SUBJECT: SEABROOK STATION, UNIT NO. 1 - ISSUANCE OF AMENDMENT
REGARDING LICENSE AMENDMENT REQUEST 12-04, APPLICATION
REGARDING COLD LEG INJECTION PERMISSIVE (TAC NO. MF1158)

SEABROOK STATION, UNIT NO. 1

AMENDMENT TO FACILITY OPERATING LICENSE

Amendment No. 140
License No. NPF-86

Figure 3.1-1 Simplified Functional Block Diagram for P-15 Modification

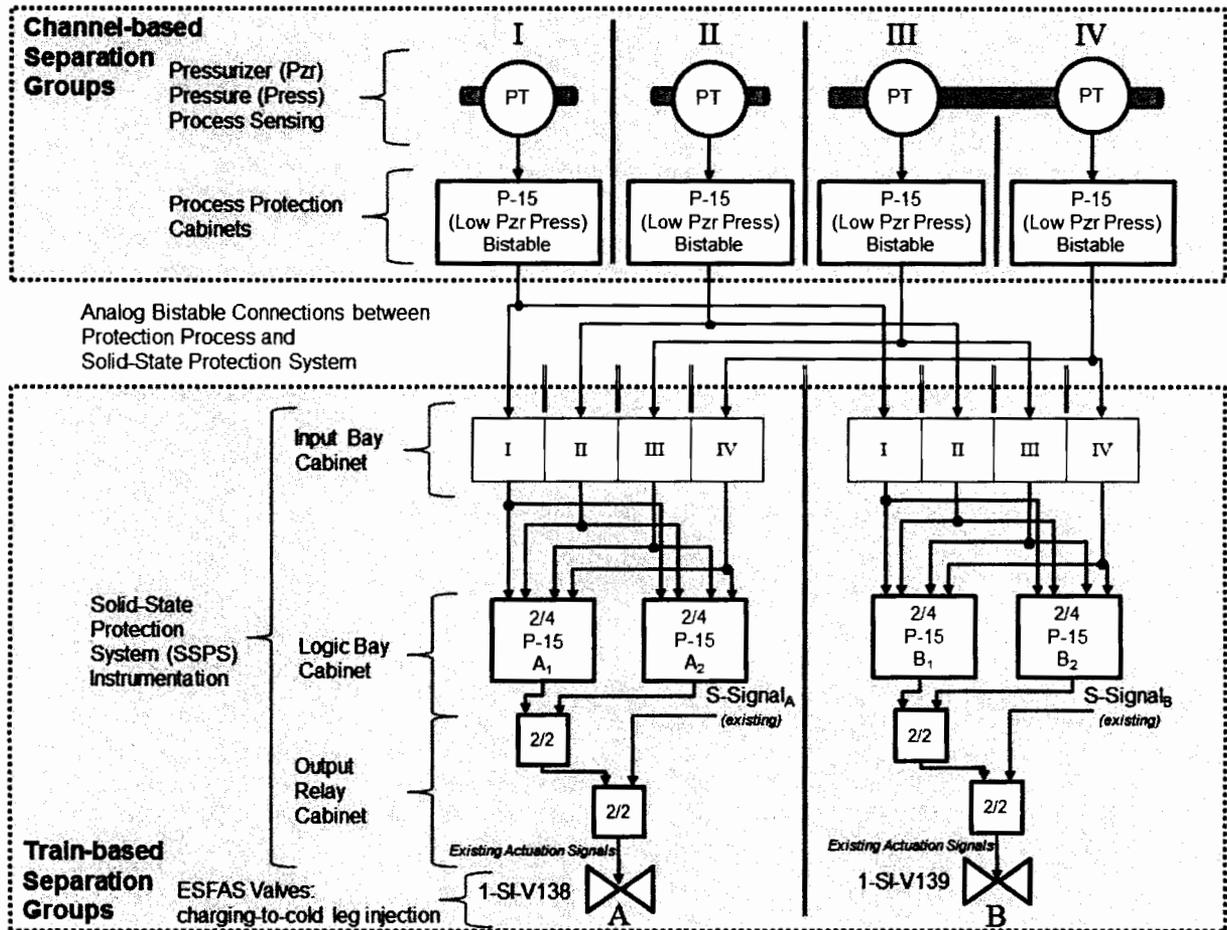
Figure 3.1-1 depicts the P-15 function, as performed by the associated equipment within the Seabrook’s safety instrumentation architecture. As shown in Figure 3.1-1, the modification for the P-15 function is consistent with the licensee’s existing instrumentation architecture for SI. This architecture includes four channels (I through IV) of pressurizer pressure transmitters, where each provides an input to one of four electrically isolated and physically separated process protection cabinets and pressurizer pressure transmitters. Channel numbers III and IV share a common sensing line. This architecture also includes two electrically isolated and physically separated trains of SSPS (A and B), where each train controls one and only one charging-to-cold-leg injection valve (1-SI-V-138 or 1-SI-V-139, respectively).

The modification adds a P-15 low pressurizer pressure bistable channel with bypass test capability to each of four process protection cabinets. Each process protection cabinet provides its P-15 low pressurizer pressure bistable as a two-state analog signal to two SSPS input cabinets. Each SSPS input cabinet is part of a separate and redundant instrumentation and control train of the SSPS.

The modification adds four P-15 low pressurizer pressure bistable inputs to each SSPS input cabinet. Consistent with the licensee’s existing safety instrumentation architecture, each low pressurizer pressure bistable signal input to the SSPS input cabinets provides an automatic monitoring point and a manual indication, which is not shown for simplicity. SSPS cabinets provide an optically isolated interface with the equipment used for automatic monitoring and manual indication to preserve electrical separation of the SSPS trains. Also, consistent with the licensee’s existing safety instrumentation architecture, physically separate circuitry within each SSPS input cabinet maintains electrical isolation via relay coils for the four P-15 low pressurizer pressure bistable signals it receives. The relay coils preserve bistable channel identity and provide coil to contact isolation between individual P-15 low pressurizer pressure bistable signals and the SSPS train’s logic. The SSPS input cabinet within each SSPS train provides the post-isolated P-15 low pressurizer pressure bistable signals to two-out-of-four voting logic within its train in a manner consistent with the licensee’s existing safety instrumentation architecture and the generation of the train’s ESFAS high-head SI signal (S-signal).

The modification implements P-15 two-out-of-four voting logic in each SSPS train’s logic cabinet in a manner consistent with the licensee’s existing safety instrumentation architecture. However, for P-15, the two-out-of-four voting logic is additionally implemented redundantly within each SSPS train. The modification uses spare SSPS logic matrices of existing components within each SSPS logic cabinet to perform two-out-of-four voting on the four P-15 low pressurizer pressure bistable signals in a manner consistent with generation of the train’s S-signal. Each of the redundant two-out-of-four voting circuits for P-15 produces its own relay control signal. For each SSPS train, its two P-15 relay control signals drive corresponding relays in a manner consistent with the licensee’s existing safety instrumentation architecture and the generation of the train’s S-signal.

The NRC staff determined the P-15 modification meets the regulatory acceptance criteria applicable to Seabrook for independence between redundant components that perform the P-15 function. This determination is based on the modification's implementation of the P-15 function in redundant components that maintain independence consistent with the Seabrook design basis.
